Bid 19C4, Urbana Elementary School Replacement – Construction Stage II

ADDENDUM NO. 4

RE: **URBANA ELEMENTARY SCHOOL REPLACEMENT**

**URBANA ELEMENTARY SCHOOL REPLACEMENT
BID PACKAGE
ADDENDUM NO. 4
21740.00**

ITEM NO. A1: SHEET A-1.1 PARTIAL FIRST FLOOR PLAN – AREA A
ADD 16” diameter Column cover at columns J:13 (Room A120) and J:14 (Room A116).

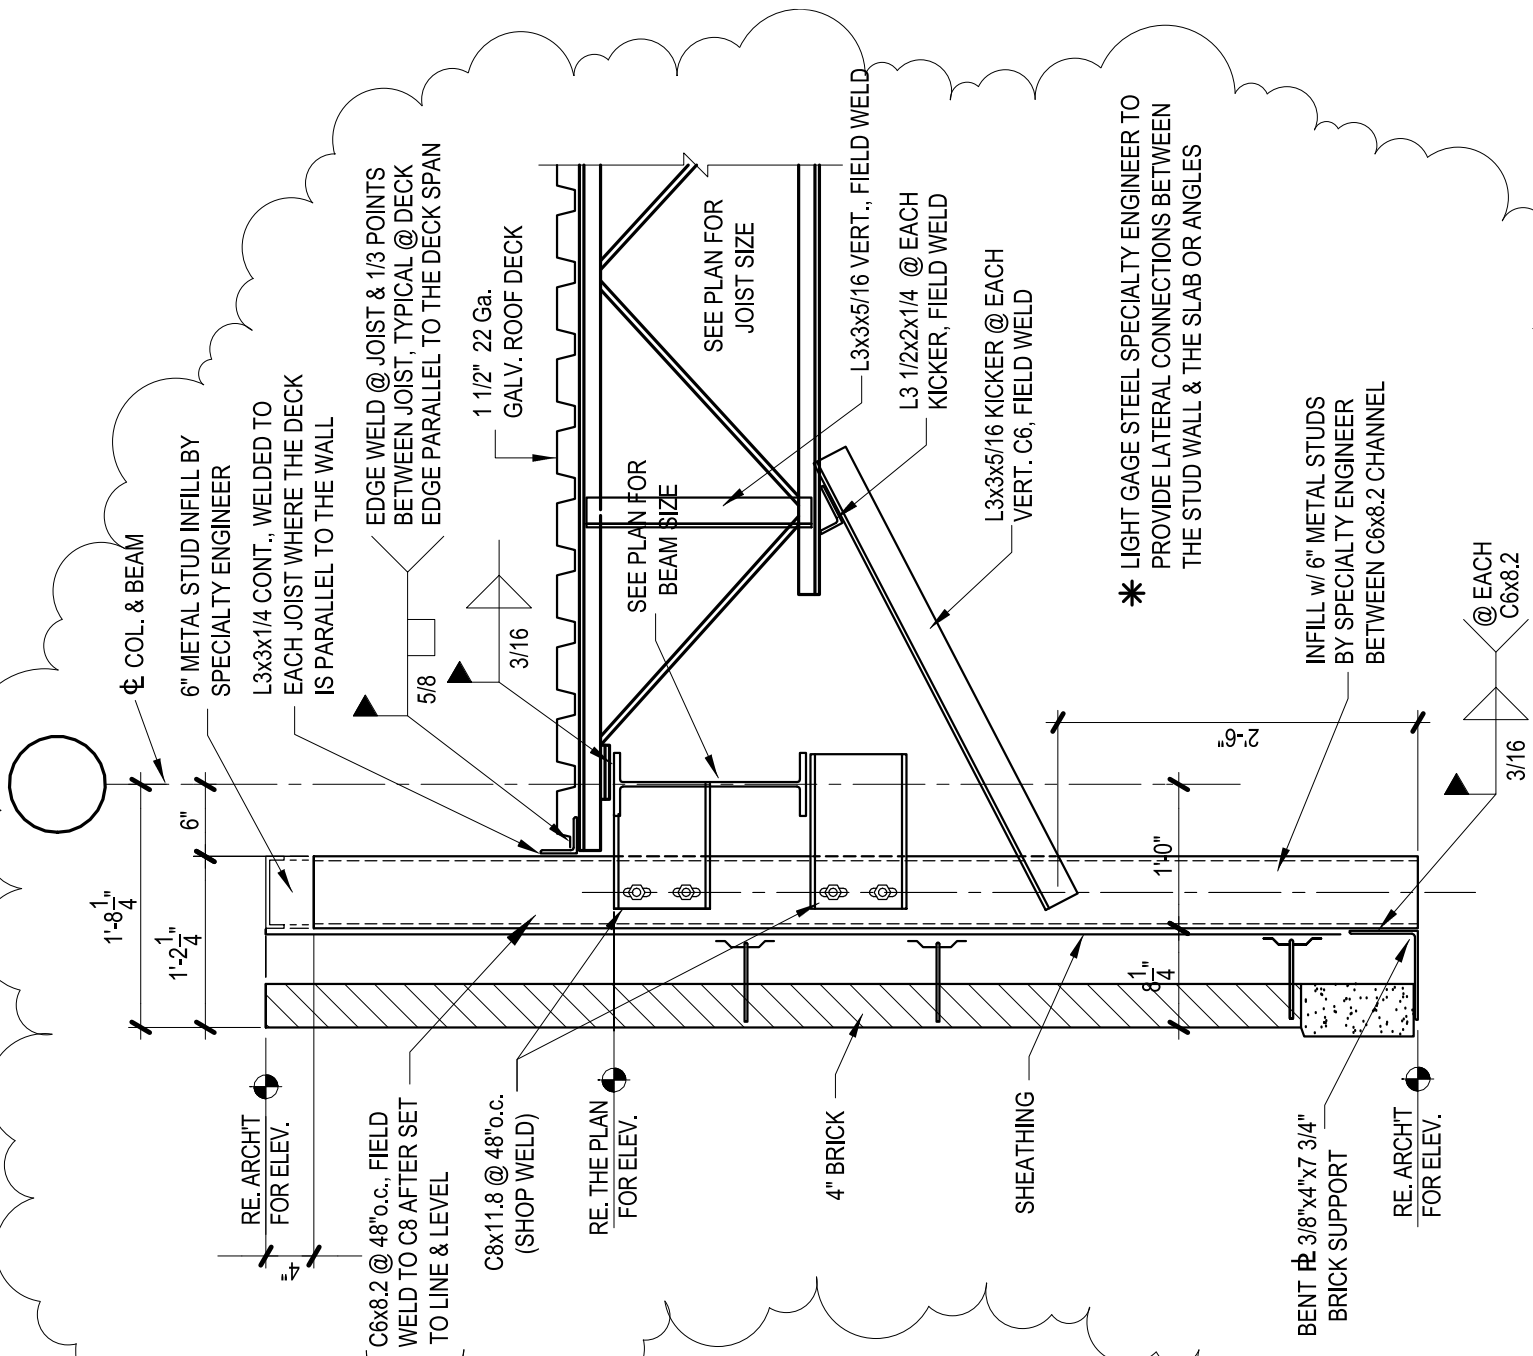
ITEM NO. A2: SHEET A-1.2 PARTIAL FIRST FLOOR PLAN – AREA B
ADD 16” diameter Column cover at column D.1:7.2 (Room B101E).

WALL FRAMING FOR OPENINGS 8'-1" & OVER

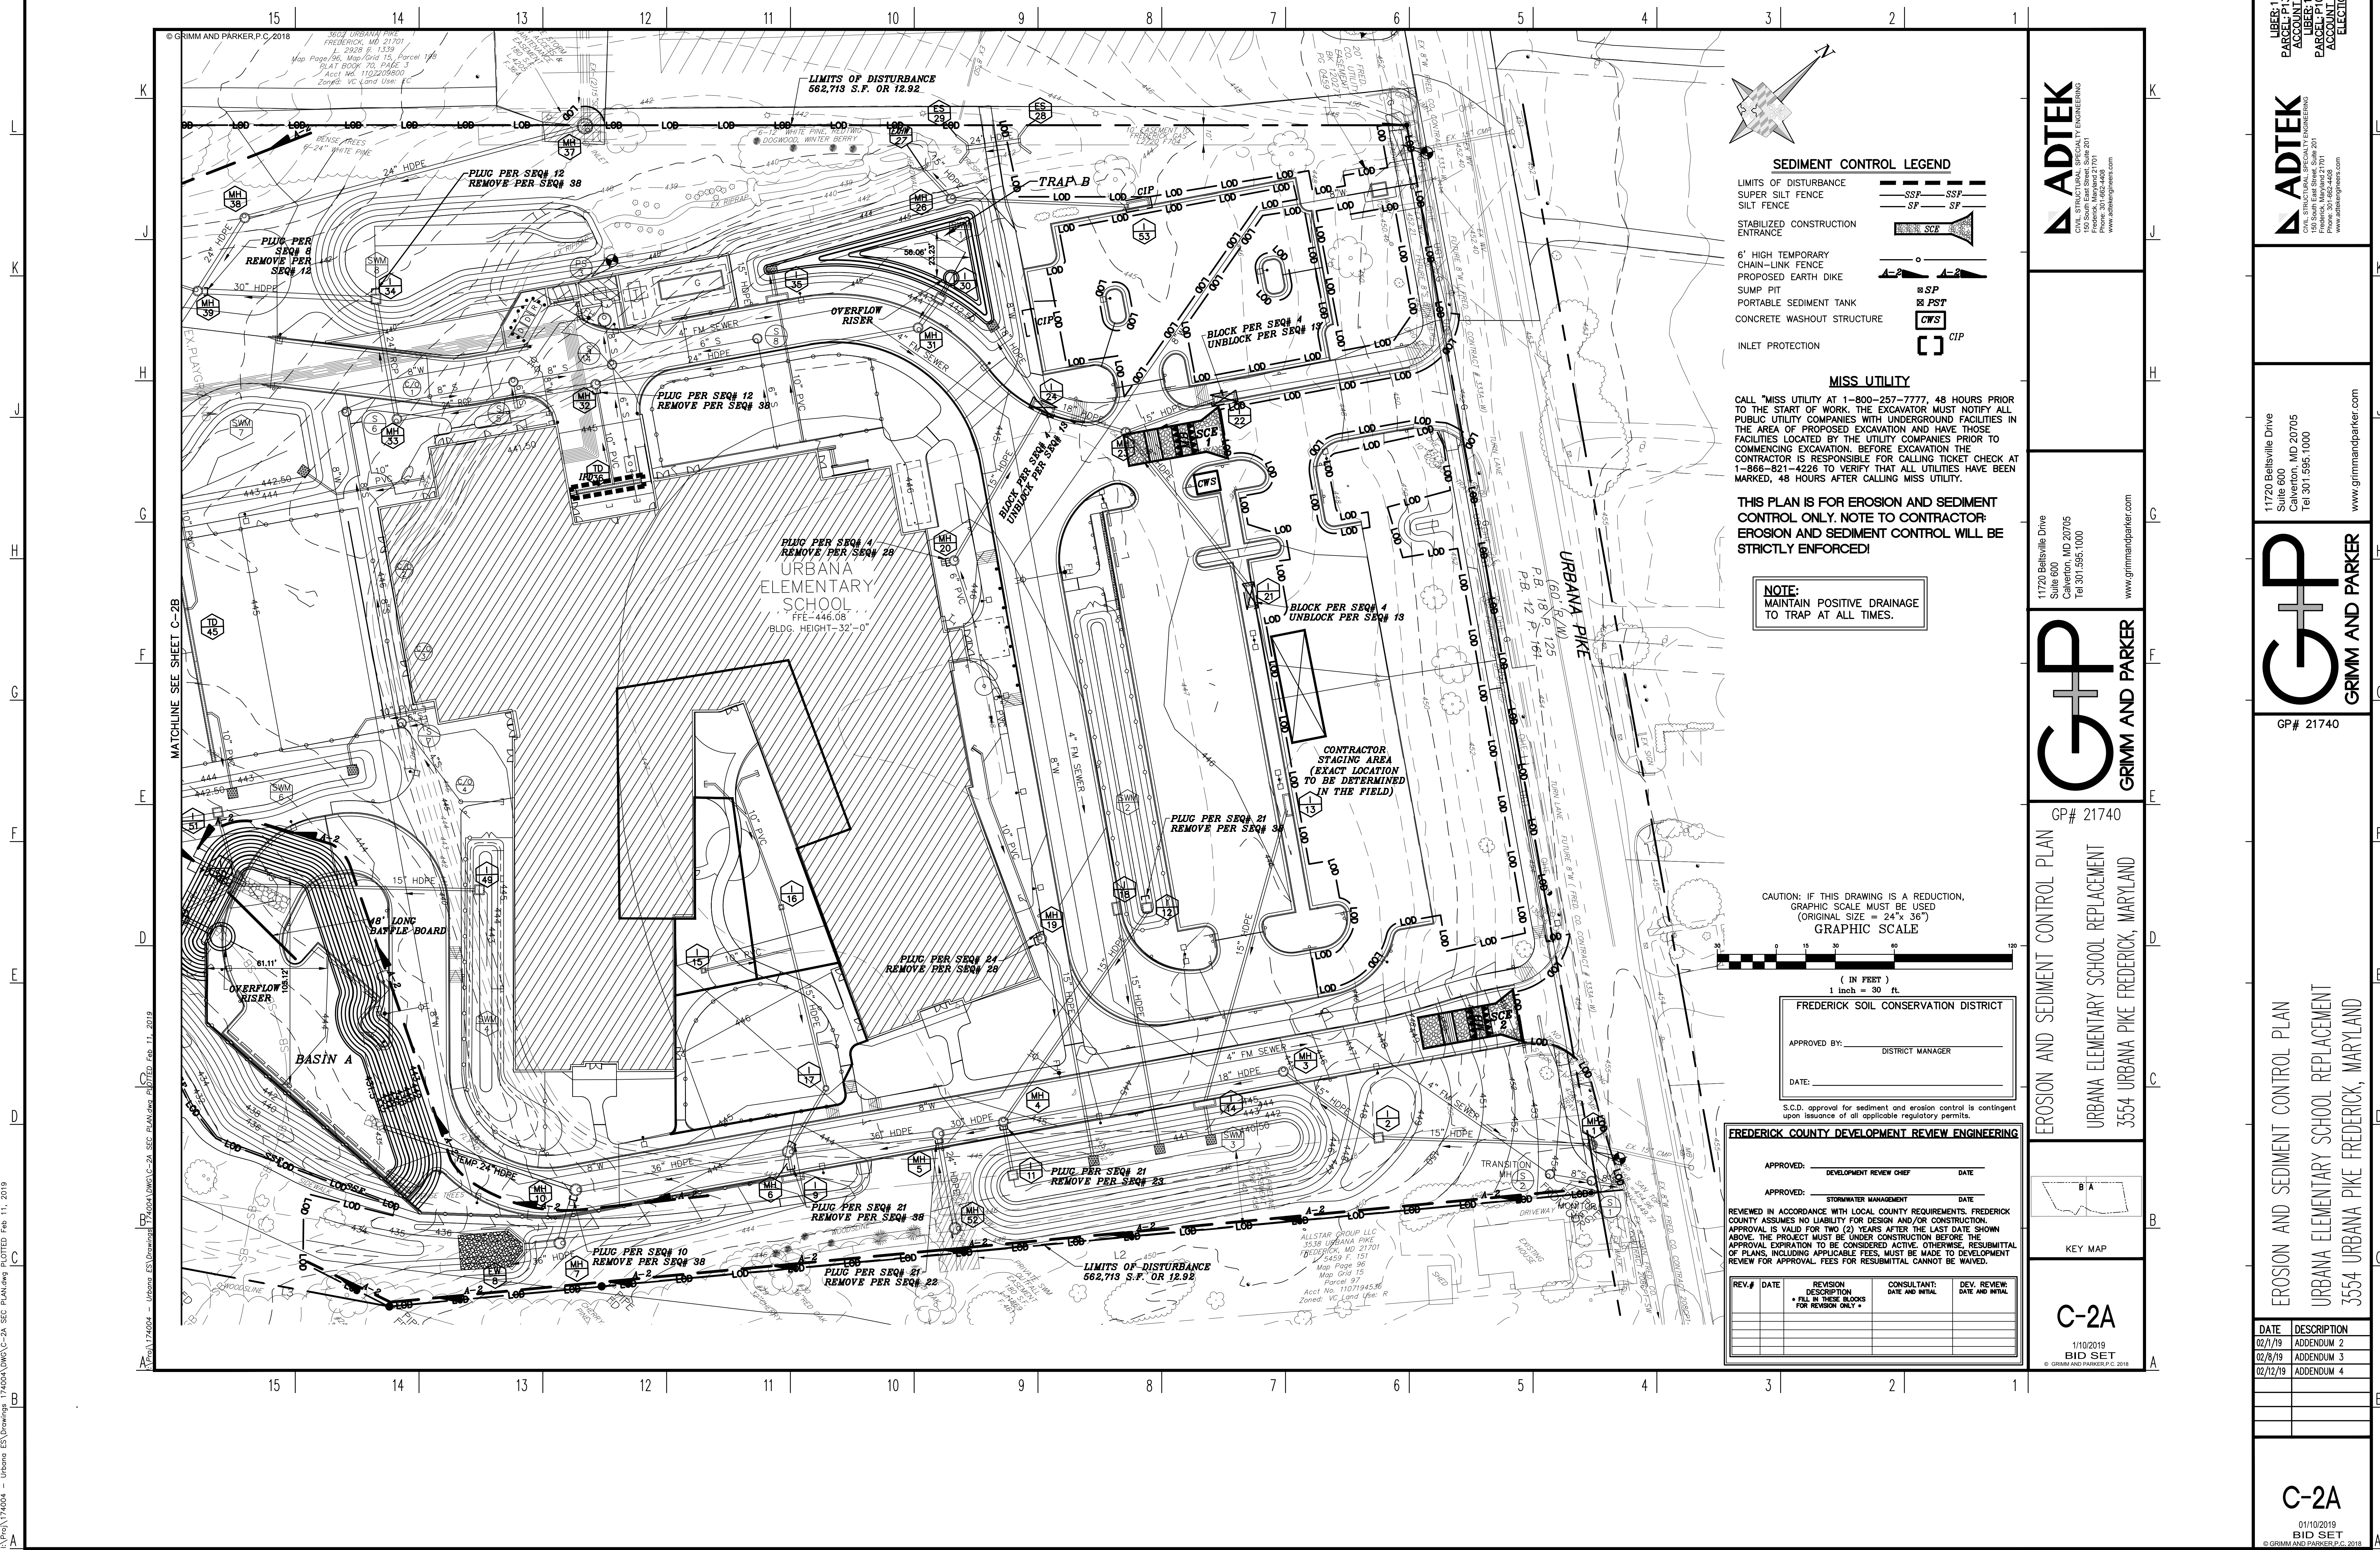
ITEM NO. S1: SHEET S-4.2 SECTIONS
SUBSTITUTE This sheet in its entirety with sheet included in this Addendum.

C-2A

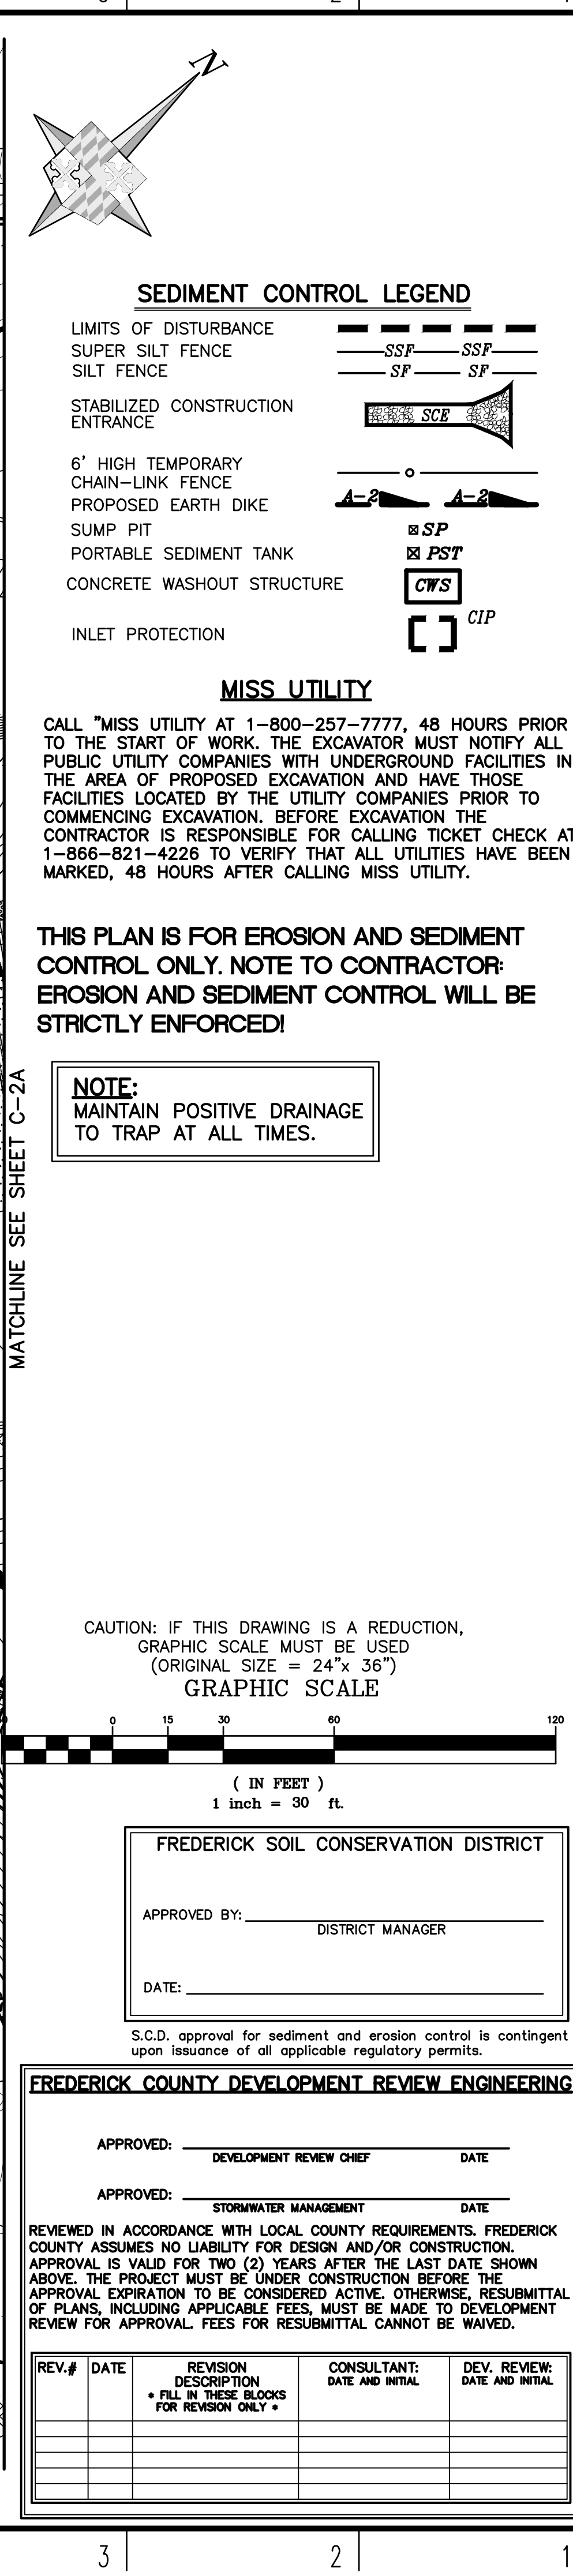
ITEM NO. C1: SHEET C-2A EROSION AND SEDIMENT CONTROL PLAN
SUBSTITUTE This sheet in its entirety with revised sheet included in this Addendum.
REVISE Sheet sequence callout notes numbers updated.
